PREVOST

WARRANTY BULLETIN

WB13-91A

DATE :	NOVEMBER 2013	SECTION :	23 - Accessories
EXPIRATION:	NOVEMBER 2015		
SUBJECT :	WIPER MOTOR REPLACEMENT

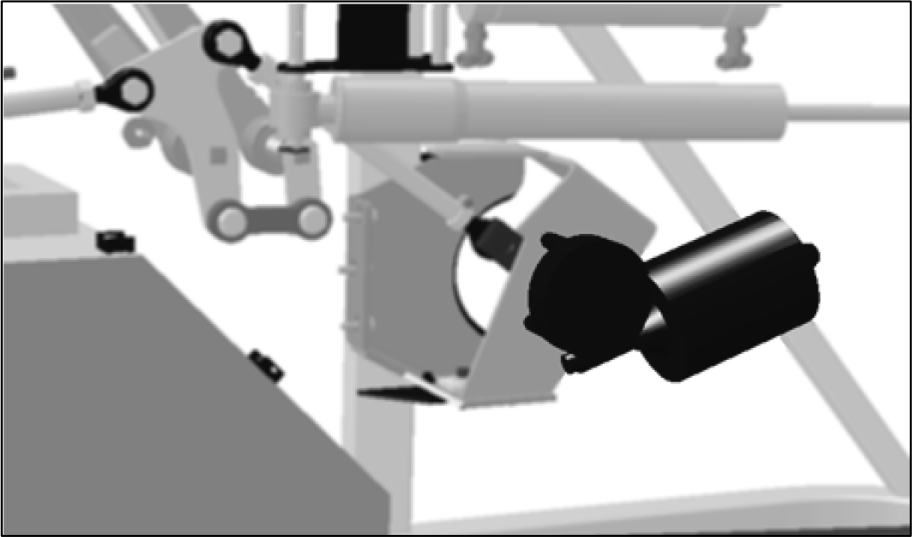
2. Remove multiplex modules A47 & A48 to gain access to the wiper motor assembly.

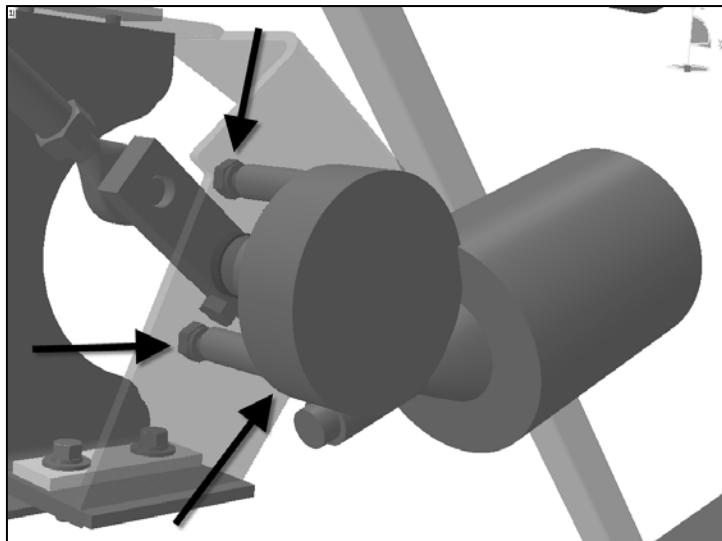
7. Install the new motor with 5001217 M8x20 screws and 5001003 lock washer.

- Assemble with Loctite
- Torque to 22 lbf-ft (dry)

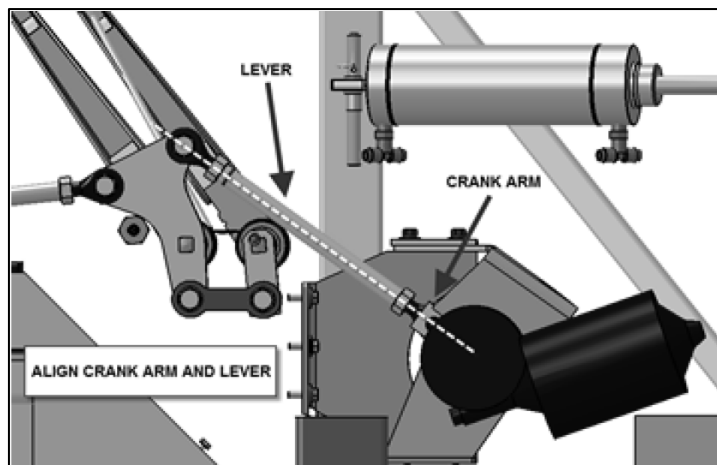
12. Reinstall the crank arm on the motor shaft so that the crank arm and lever axis are aligned as shown, the lever inclined to the left.
